UNITED STATES OF AMERICA  
NUCLEAR REGULATORY COMMISSION

INTERIM DIRECTOR'S DECISION UNDER 10 CFR 2.206

SAFETY EVALUATION BY THE OFFICE OF NUCLEAR REACTOR REGULATION  
SUPPORTING DIRECTOR'S INTERIM DECISION  
UNDER 10 CFR 2.206 (SEISMIC CAPABILITY OF EMERGENCY FEEDWATER)

THREE MILE ISLAND NUCLEAR STATION, UNIT NO. 1

TMI-1 "AUX FEEDWATER SYSTEM"  
 J.T., 36ARD 12/28/72

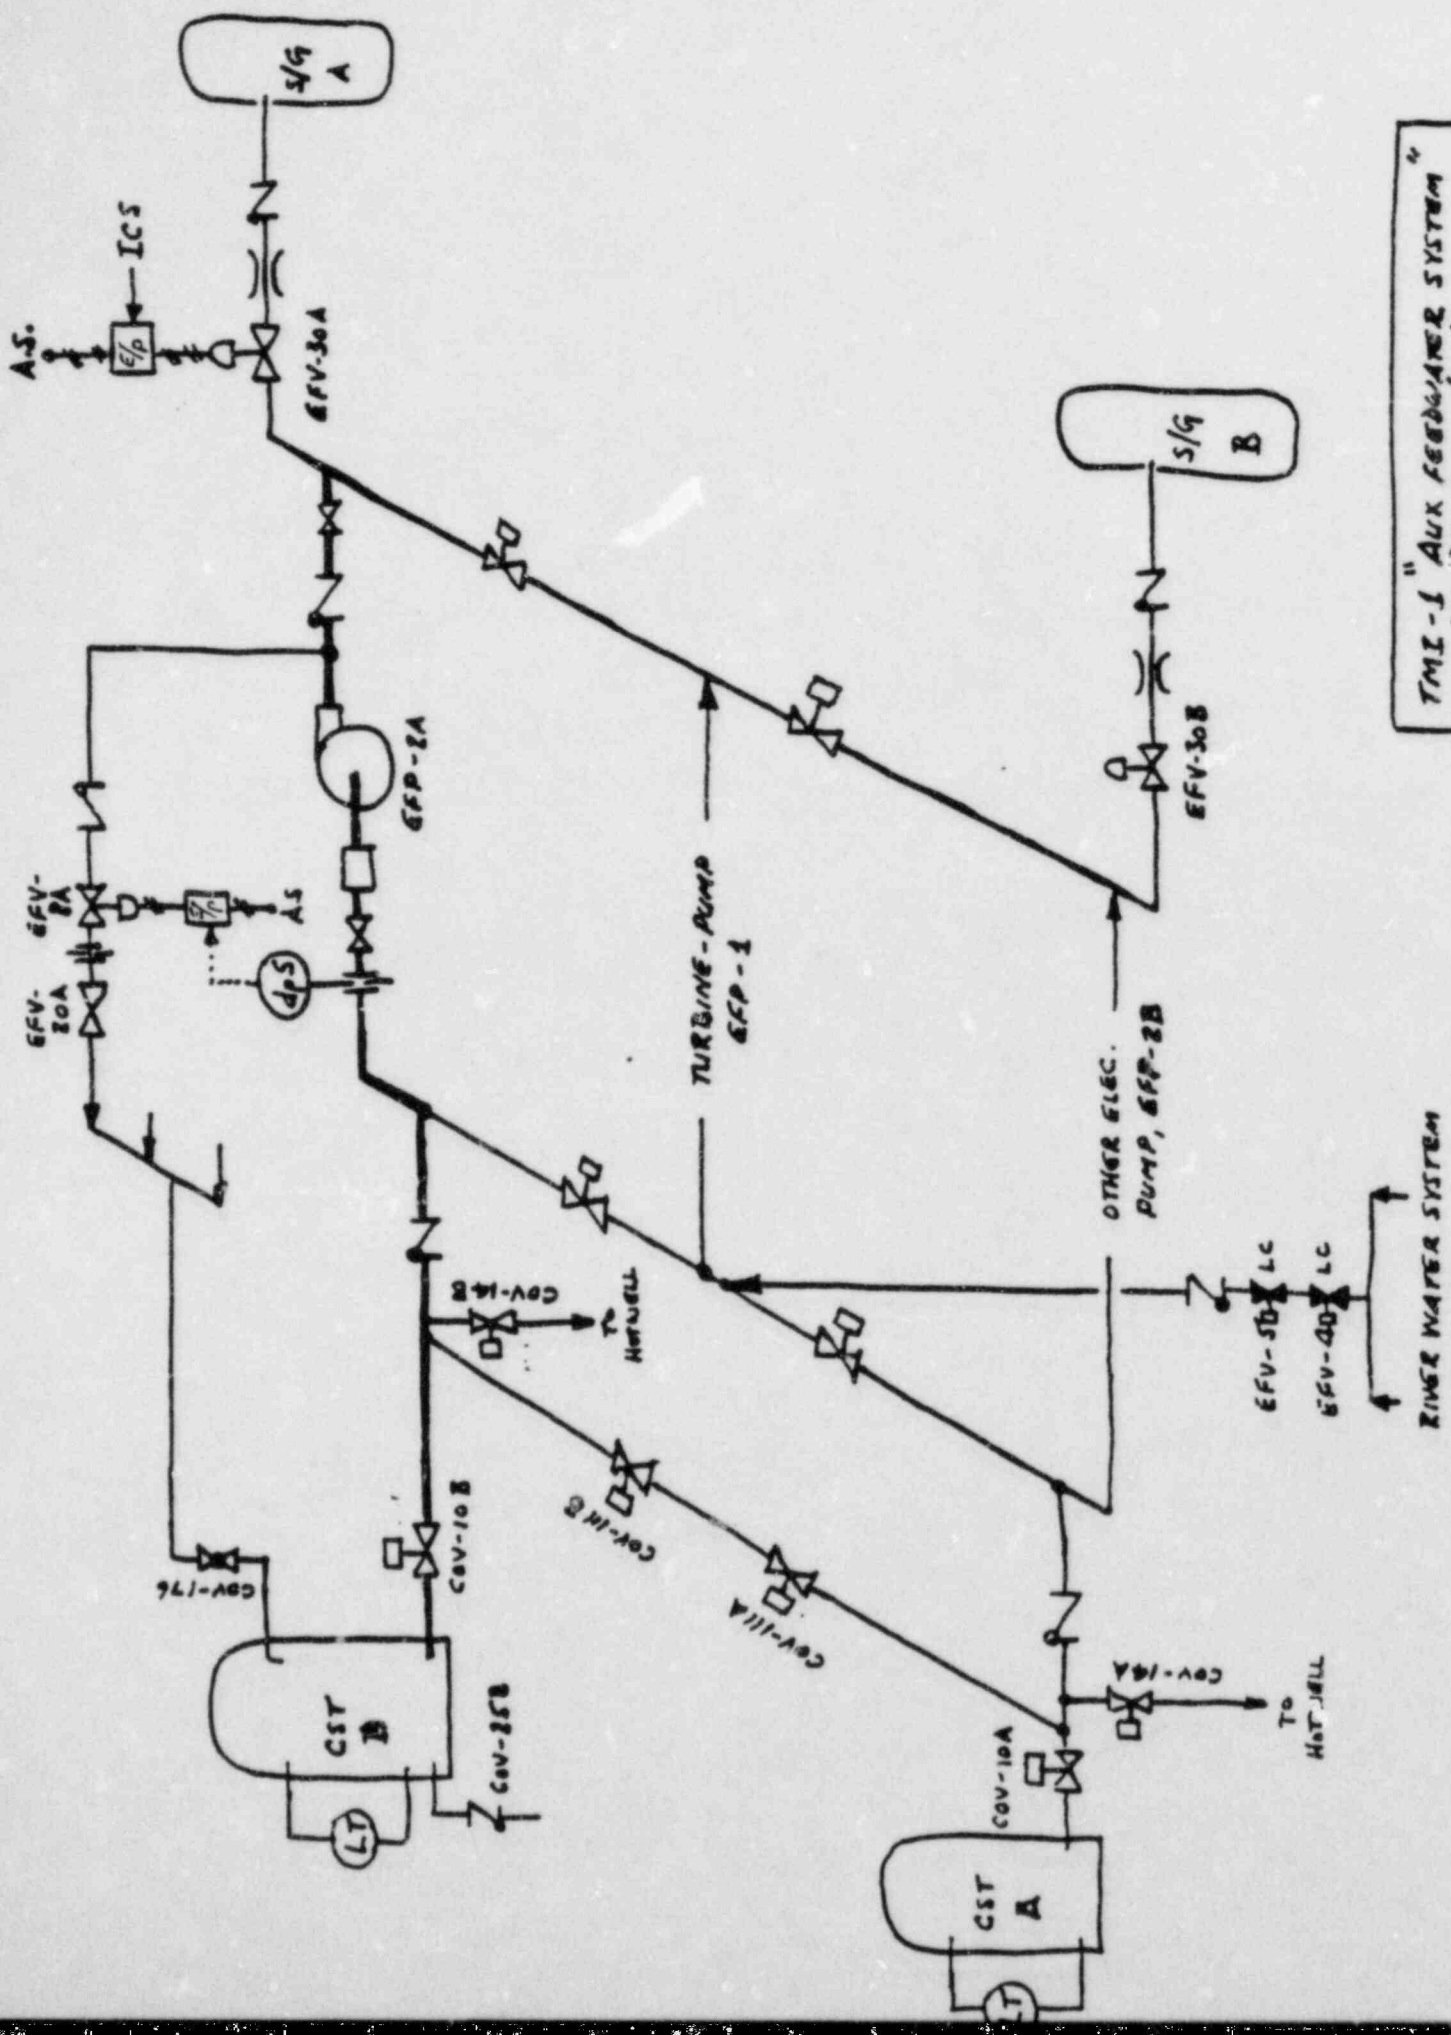
The petition claims that sources of cooling water for the EFW system will not be available following an SSE as a result of the postulated failures of the Condensate Storage Tank (CST) low level alarms, failures of the isolation valves CO-V-14A, B (which isolate the CST's from non-seismic piping to the condenser hotwell), and the inability of an operator to perform local actions due to a postulated steam environment. The enclosed sketch of the EFW system shows the various numbered valves.

Isolation of the CST from the non-qualified piping would normally be a remote manual action in that it would be performed from the main control room. However, the operator may find that his actions are not effective. Failure of the isolation valves (CO-V-14A, B) could occur due to either of two possible causes. The valve could fail to respond to the control room initiation due to loss of electric power to the motor operated valve, due to lack of seismic power cable installation through the turbine building. For this case, an operator would be dispatched to the valve location to close the valve manually. These valves are located in the corridor outside the EFW pump rooms. The failure of the valve due to loss of electric power would not affect the operator's ability to manually operate the valve and a handwheel is provided on the valve for this purpose. This local manual operator action is prescribed by plant procedures (#1202-30). The staff's review of the licensee's analysis indicates that if this procedure is completed within 20 minutes of the seismic event, the quantity of water remaining in one CST will be sufficient. In order to provide additional assurance, we visited the plant, performed a procedural walk-through, and concluded that the operator could get to the area and complete the required actions in less than 15 minutes, with a typical time of about 5 minutes.

Failure of the isolation valve could also occur as a single random failure. In this case, local manual actions might not be effective. Since either of the two CSTs has sufficient inventory for the EFW safety function, the loss of one of the tanks due to a valve failure is not unacceptable so long as the CSTs are isolated from each other. Consequently, plant emergency procedures also require that, upon receiving the seismic event alarm, the CST cross-connect valves (CO-V-111A, B) be closed immediately by operator action, either remotely from the control room or locally in the event of a power loss. These valves are located in the same corridor as CO-V-14A, B. Therefore, we conclude that, even if the failure of non-seismically qualified components is

There are two areas of non-seismically qualified piping related to the EFW system: first, a portion of the recirculation lines downstream of both the flow restricting orifices and the isolation valves and outward toward CST "B"; and second, at the interface with the condensate system, the feed lines from the CSTs downstream of isolation valves CO-V-14A,B and outward to the condenser hotwell.

considered and a single failure is simultaneously considered, the CSTs would still remain capable of providing a sufficient source of water for the EFW system. Moreover, in the event both CSTs were to be lost, the plant configuration includes a fully qualified safety-related alternate source of water known as the Emergency River Water System.
